SUBJECT: Transmittal of Revised Responses to AP1000 DSER Open Items

AP1000 Design Certification Review
Draft Safety Evaluation Report Open Item Non-Proprietary Responses

DSER Open Item Number: 19.1.10.1-5 (Response Revision 1)

Original RAI Number(s): 720.009, 720.012, 720.013, 720.014, 720.017, 720.021, 720.024, 720.025

Figure A3.5-12

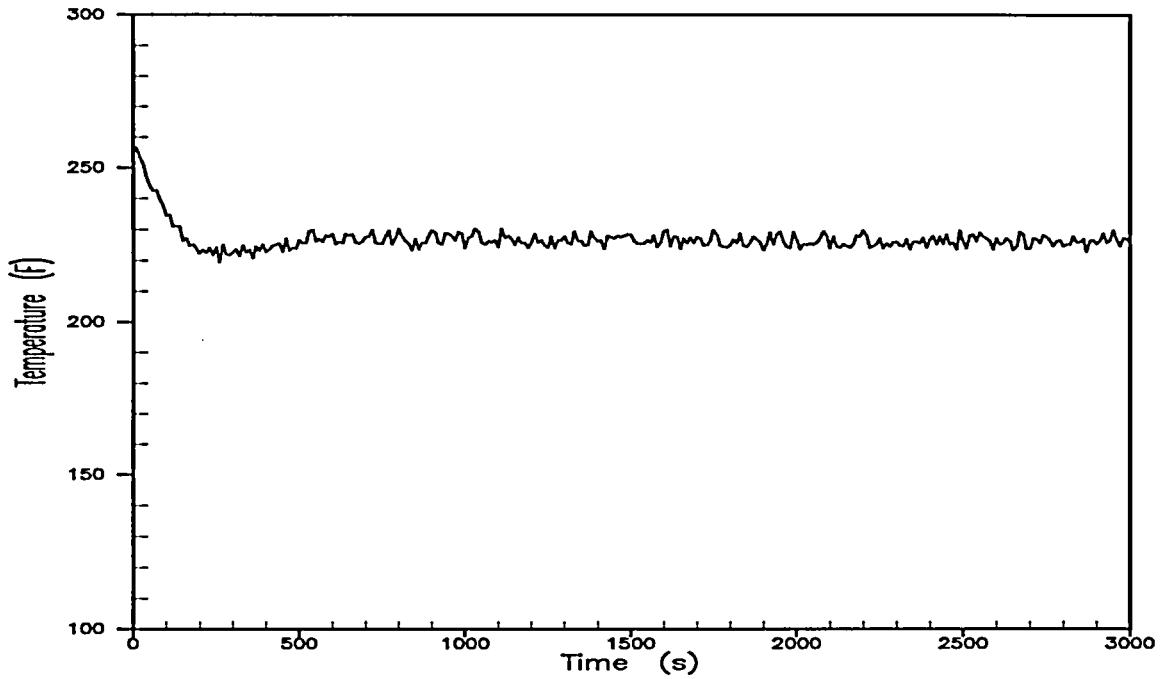
This issue is unresolved. In the revised response to RAI 720.09, Westinghouse presented the results of an analysis using WCOBRA/TRAC with inputs determined from a MAAP4 analysis. The staff has the same issue with this analysis as is stated under Item a. In the revised response to RAI 720.17, Westinghouse argued that this case is not risk significant and therefore it is not necessary to perform a T&H uncertainty analysis. This argument is not valid since OK6 (See Figure 2-4 of RAI 720.012), OK2 and OK4 sequences (on Figure 2-5 of RAI 720.012) fall in this category. Are these OK sequences considered to be low risk?

- (f) The long term cooling success criteria analysis in the revised response to RAI 720.09 (3 of 4 ADS4, containment isolation failure) has now been performed using the revised WCOBRA/TRAC model and using input conditions from WGOTHIC. The revised analysis replaces the previous one as shown below in the revision to PRA Appendix A. This confirms the success criteria for this case. With respect to the statement we made in RAI 720.017 rev 1 about a T&H uncertainty case with 3 ADS-4 valves and failure of containment isolation, we have the following response. Such a sequence is not risk important with the current expanded event trees. The question regarding sequences that we identified as OK sequences with 3 ADS-4 valves and CI failure is a new / different question. These sequences are less severe than the success criteria case in that they have some ADS 2/3 valves opening and have 1 CMT (in addition to 1 Accumulator). The addition of the CMT will compensate for the water lost out of the containment through a failed CI. In addition, these OK sequences have probabilities of ~ E-10 / yr, or less. The highest UC sequence with 3 ADS-4 and failed CI is UC8/sad27, see PRA Appendix A Table A5.1-2. This sequence has a CDF probability of 2 E-10 and is not risk important.

Initially, the only injection comes from the IRWST into the reactor vessel through the intact DVI injection line (Figure A3.5-14). At the beginning of the analysis, the liquid level in the PXS-B room is below the DVI injection nozzle elevation and steam from the downcomer is vented out through the break (Figure A3.5-13). Water starts to flow back into the downcomer through the broken DVI line during the transient when the liquid level in the PXS-B room becomes high enough to provide sufficient driving head. With the onset of this flow, additional water supplied

into the downcomer through the DVI break supplements the IRWST injection. As this flow path becomes established, the levels in the downcomer (Figure A3.5-1), the reactor core (Figure A3.5-2), and the upper plenum (Figure A3.5-8) are sufficient to maintain core cooling. The effect of this injection flow increase is also seen in Figures A3.5-3 and A3.5-4, which show a void fraction decrease in the upper half of the core.

The three available ADS Stage 4 valves provide enough venting capacity that adequate depressurization capability exists to achieve successful performance of the passive safety systems (Figures A3.5-9 and A3.5-10). The fuel remains covered throughout the transient, and adequate core cooling is provided to remove the decay heat. The hot rod cladding temperature at the top of the core is slightly above saturation temperature (Figure A3.5-12) throughout the transient.
